**Committee of Experts on the Transport of Dangerous Goods
and on the Globally Harmonized System of Classification
and Labelling of Chemicals**

**Issues relating to the Globally Harmonized System
of Classification and Labelling of Chemicals:
classification criteria for flammable gases**

**Comments on document ST/SG/AC.10/C.3/2016/58-
ST/SG/AC.10/C.4/2016/12**

Note by the secretariat

Decision logic 2.2

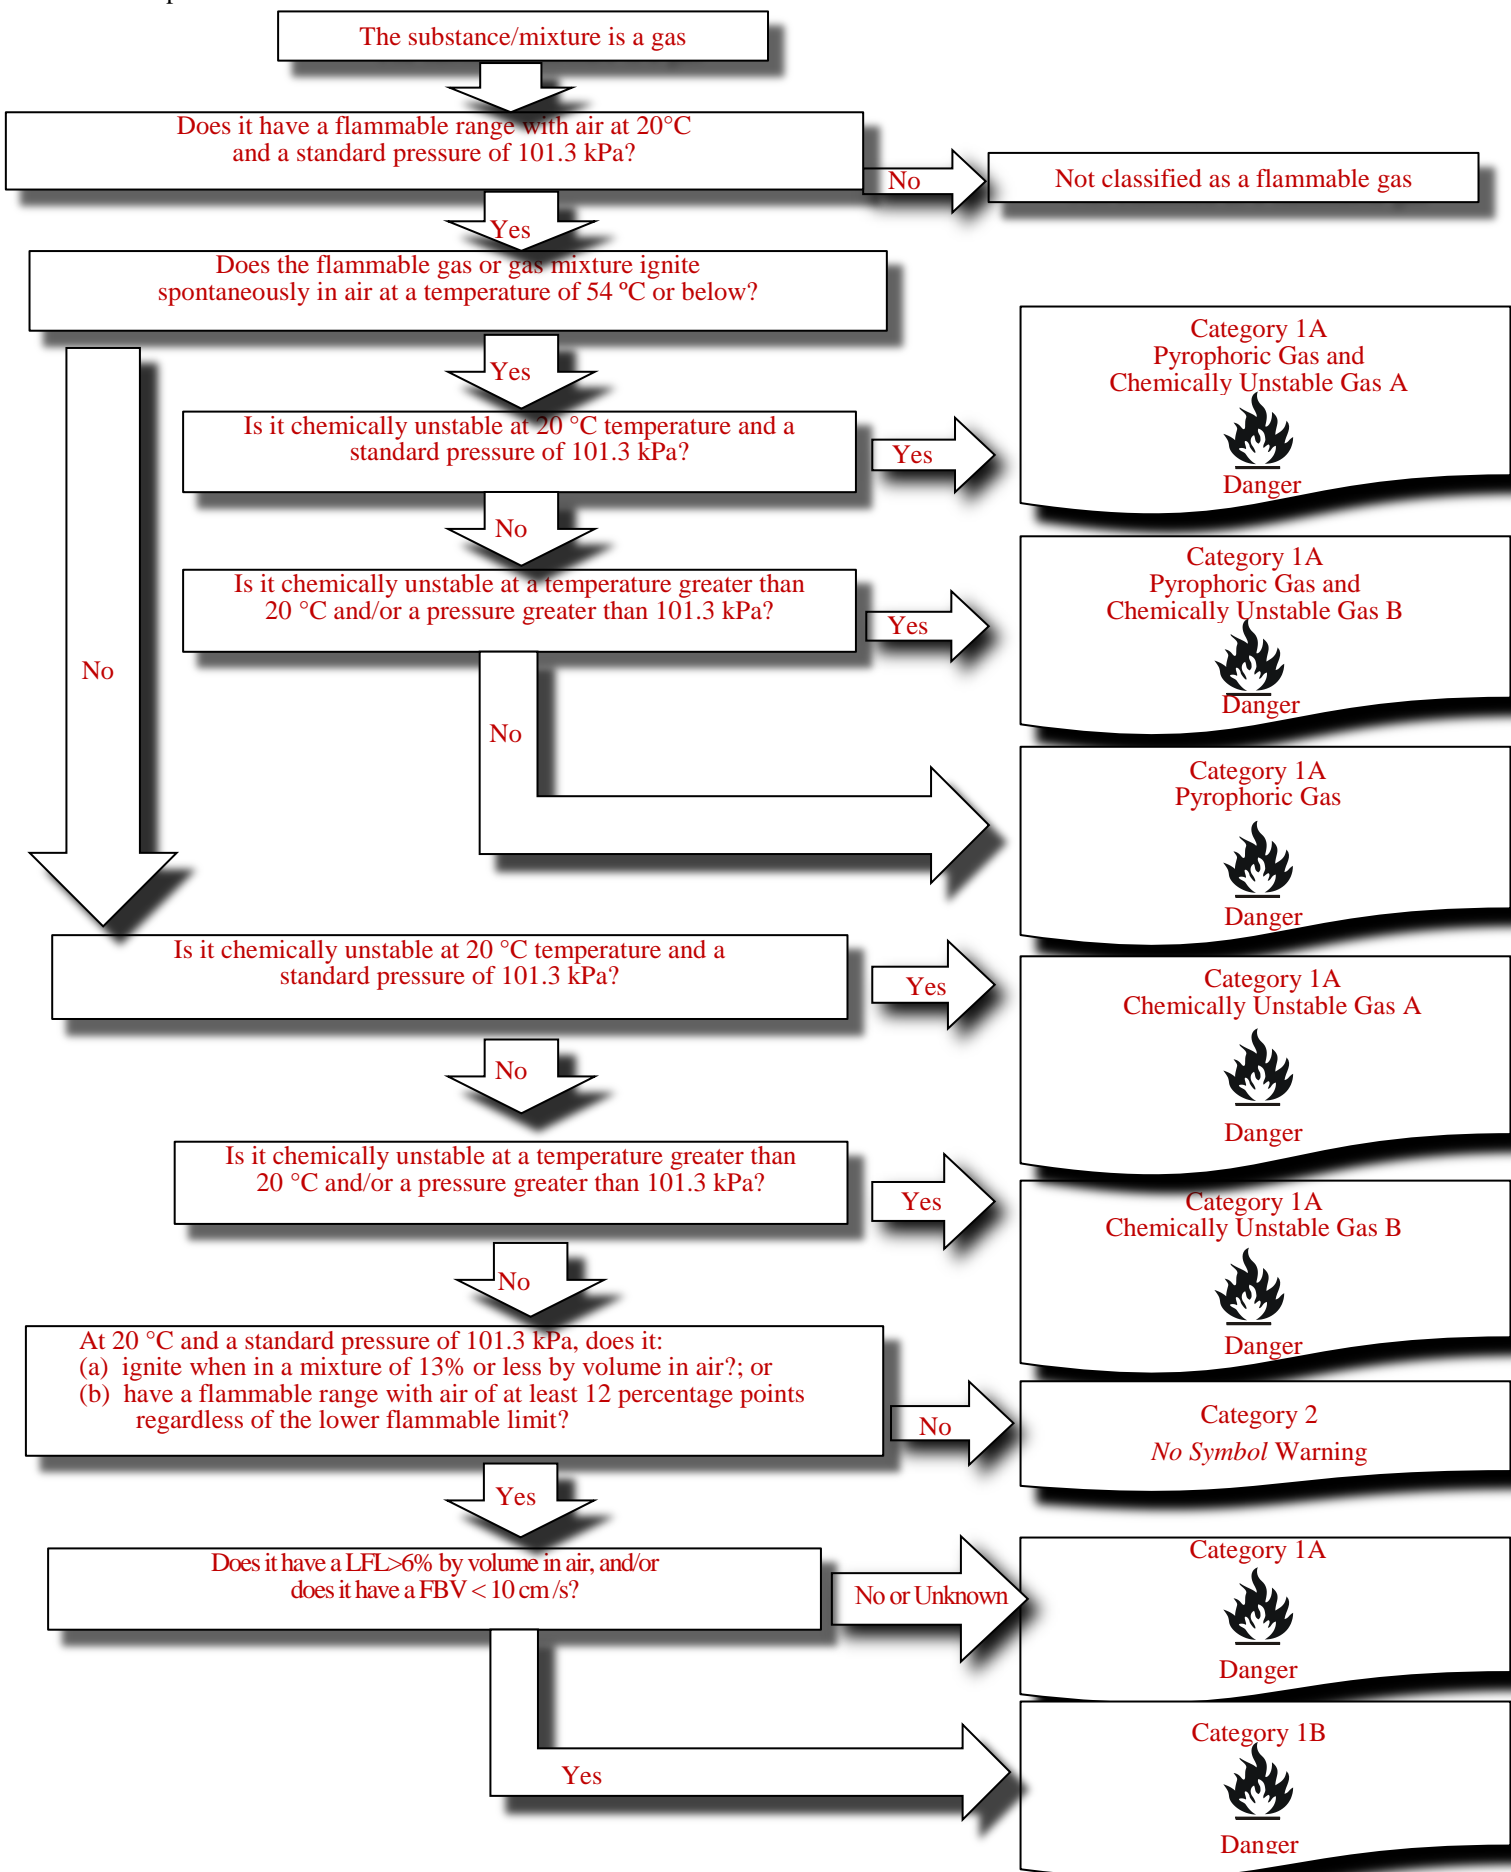
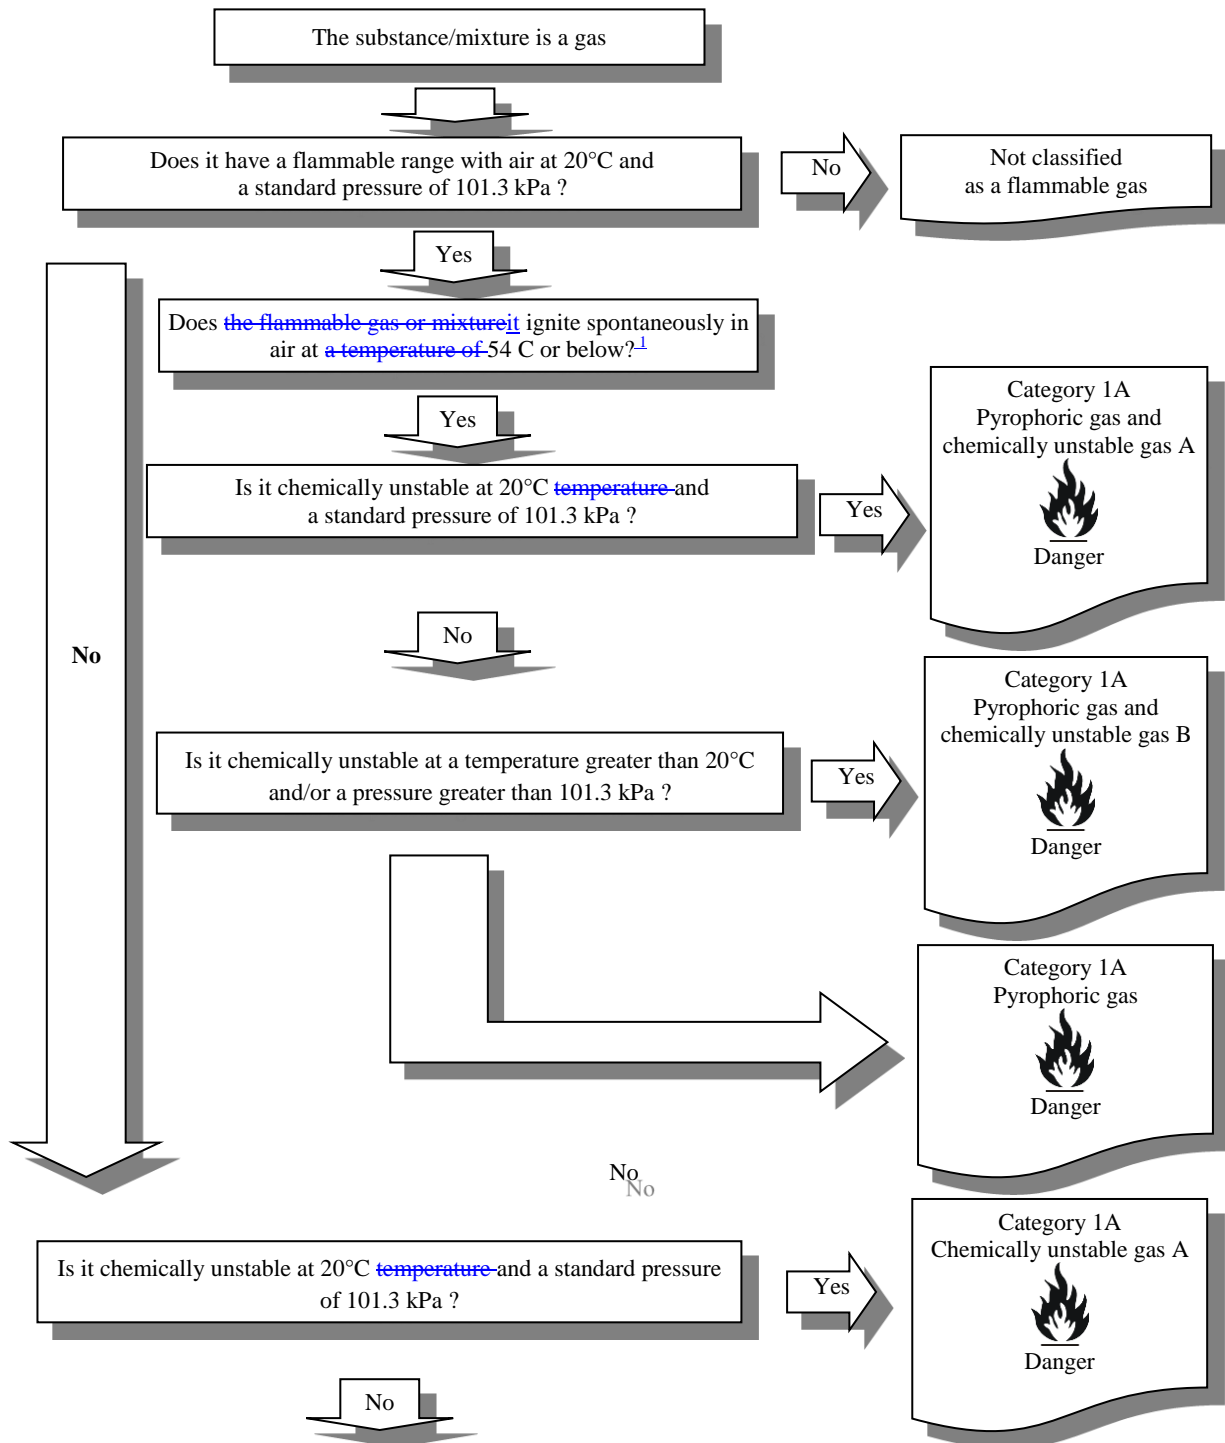
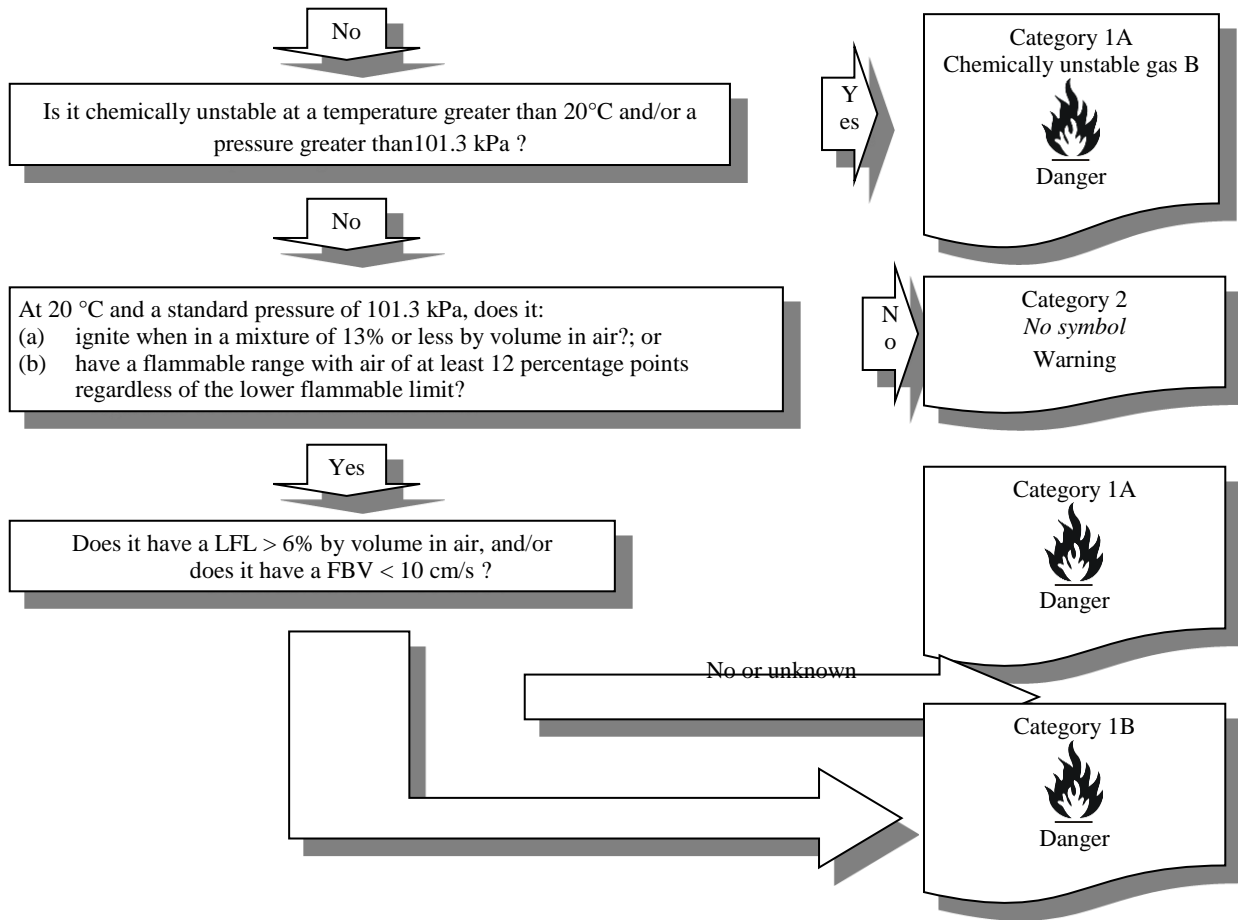
Split the decision logic so that it fits within the margins of the document and avoid overlapping of text boxes.

Insert the missing reference to footnote 1 in the decision logic, at the end of the question “Does the flammable gas or gas mixture ignite spontaneously in air at a temperature of 54°C or below?”

Consider the editorial amendments to the text of some of the decision logic (*this will allow gaining some extra space*).

Replace:

With the following, as amended (*proposed changes are indicated*):
